AMENDMENTS TO THE DRAWINGS

Application No. 09/851,841 Amendment "A" dated May 4, 2005 Reply to Office Action mailed February 23, 2005

FIG. 3

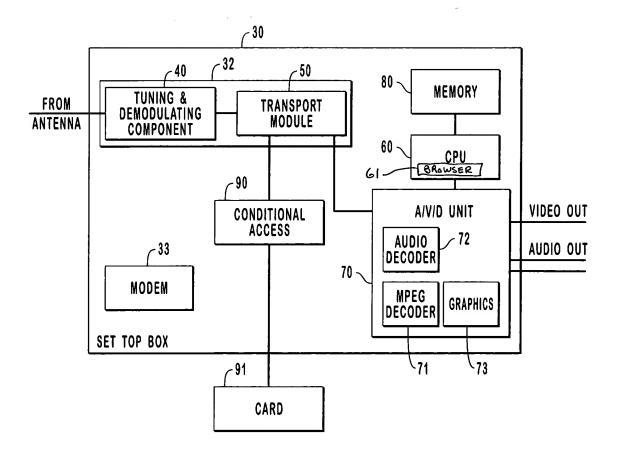
In order to comply with 37 CFR 1.83(a), Figure 3 has been amended to show a browser 61 included in CPU 60. Support for the amendment to Figure 3 is found at least at page 11, lines 20-21, page 12, lines 14-15, page 17, lines 3-4, and page 19, lines 19-21 and in the originally filed claims 1 and 8.

Lastly, the drawings were objected to under 37 CFR 1.83(a). More specifically, the office action indicates that the claimed "browser component" of claims 1, 8, and 18 must be shown or the features canceled from the claim(s). Accordingly, Figures 3 and 4 have been amended to show a browser. Corresponding references to the browsers in Figures 3 and 4 have been added to the specification. Support for the amended Figures and corresponding references in the specification is found in numerous locations in the specification and claims as previously indicated in the amendment to the drawings section of this response. No new matter is believed to have been entered as a result of the drawing and specification amendments. Accordingly, Examiner is requested to reconsider and withdraw this objection.

FIG. 4

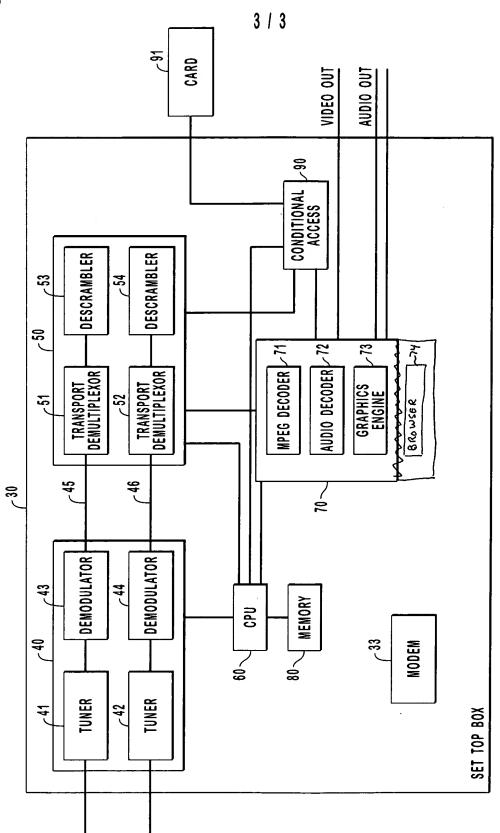
In order to comply with 37 CFR 1.83(a), Figure 4 has been amended to show a browser 74 included in A/V/D unit 70. Support for the amendment to Figure 4 is found at least at page 12, lines 16 -17, page 17, lines 3 - 4, and page 19, lines 19 - 21 and in the originally filed claim 18.
